Central Michigan District Health Department

Address: 515 W ARTHUR

PERMIT TO CONSTRUCT AN ON-SITE TYPE III/COMMERCIAL WATER WELL SYSTEM

Permit Number: 144755

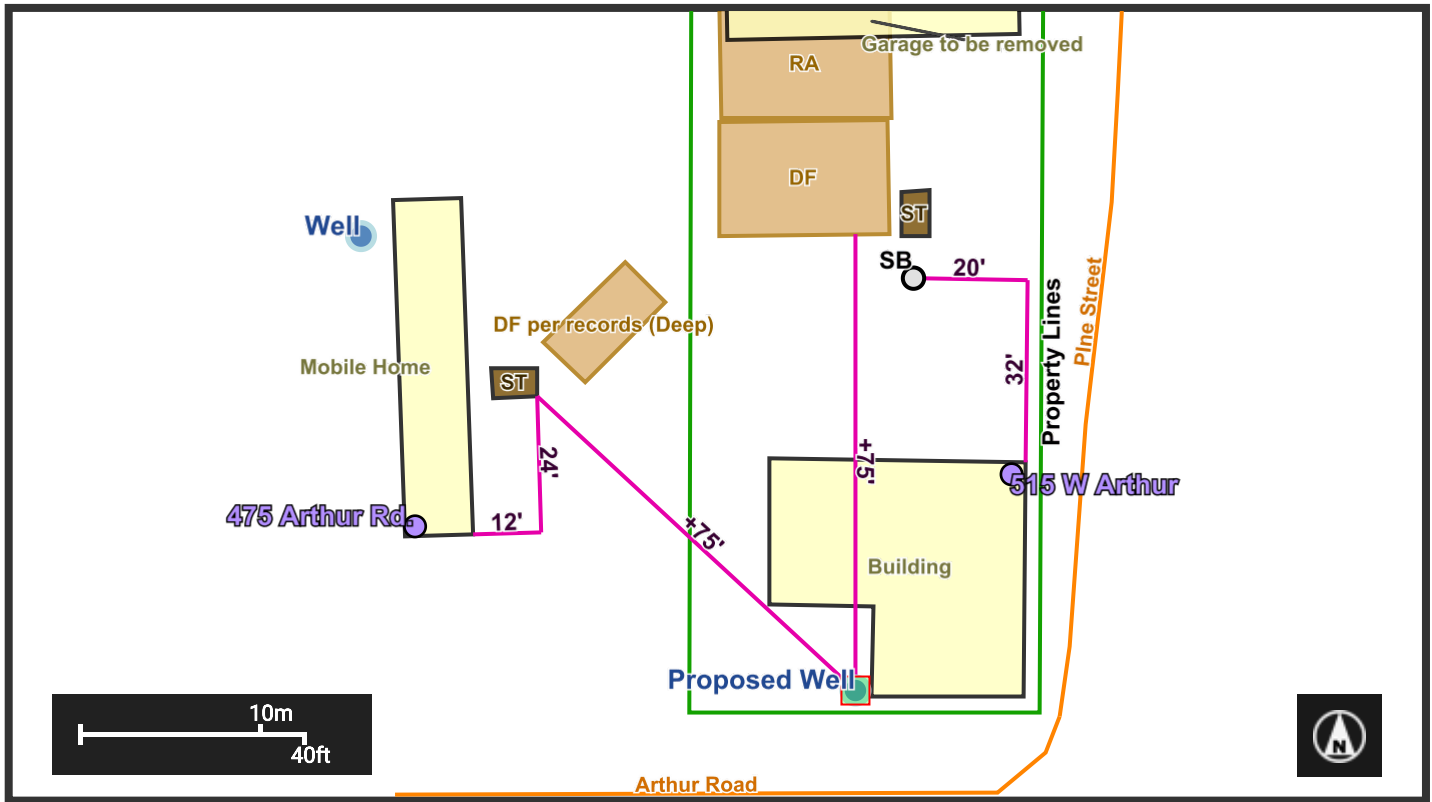
Maintain 75' from well to any onsite sewage disposal system.

Well must not be located in Public Utility Easement.

See the above drawing for site sketch showing the well location.

HIGH NITRATE AREA. Recommend field testing for nitrates. Any Primary MCL exceedance can be harmful to human health and will result in a non-approval of the well.

The proposed well is located greater than 800 feet (Approx. 1350 feet) northeast of any known PFAS detection in the MPART Lake George Area of Interest. In addition, the proposed well is upgradient of this area, as groundwater flow is generally southwest. This department recommends penetrating a minimum of 10' of clay for added protection and recommends testing for PFAS.
